28th April 2020

Selwyn District Council

Re: PC190063: MERF AG SERVICES LTD & MATTHEW REED PRIVATE PLAN CHANGE: REQUEST FOR FURTHER INFORMATION

Figure 1: Existing Zoning

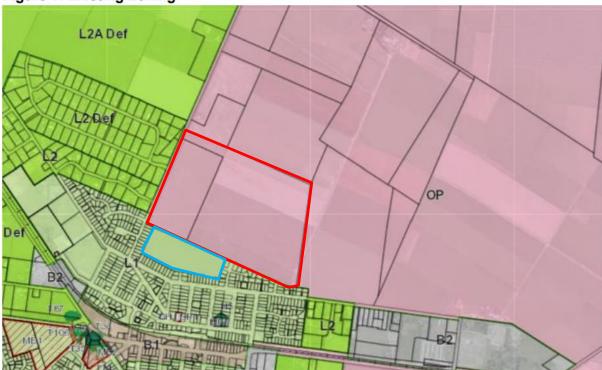
While the proposed L1/L1 deferred zone for the site is consistent with the development to the south, it is at a significantly higher density than the land zoned L2 deferred to the west.

This potentially creates an adverse amenity effect at the interface between the established land use and the proposed land use. Currently the residents of the L2 deferred area have an expectation of wider open areas and larger allotment sizes surrounding their properties, than would be found if they were L1 zoned.

- a) Make an assessment of the actual or potential effects on the landowners of property within this area; and
- b) Provide details of any mitigation measures.
- The Site of proposed Plan Change 63 is opposite land zoned L2 and L2 Deferred see zoning plan below: (the PC63 site to be rezoned L1 is outlined in red and the adjoining existing L1 land included in the PC63 ODP is outlined in blue).

2. Both the L2 and L2 Deferred zones are fully developed (Kowhai Drive and Landsborough Drive) as shown in the aerial photograph below.

3. There are six L2 sized sections along the opposite side of Kimberley Road from the Plan Change site. In each case the dwellings are oriented north/north west away from

Kimberley Road, towards the sun and views of the Alps. They are well setback from Kimberley Road (by between 11 - 30m). The Kimberley Road frontage is in most cases landscaped, and used for vehicle access, manoeuvring and garaging. The main outdoor living areas are also oriented north/north west well away from Kimberley Road.
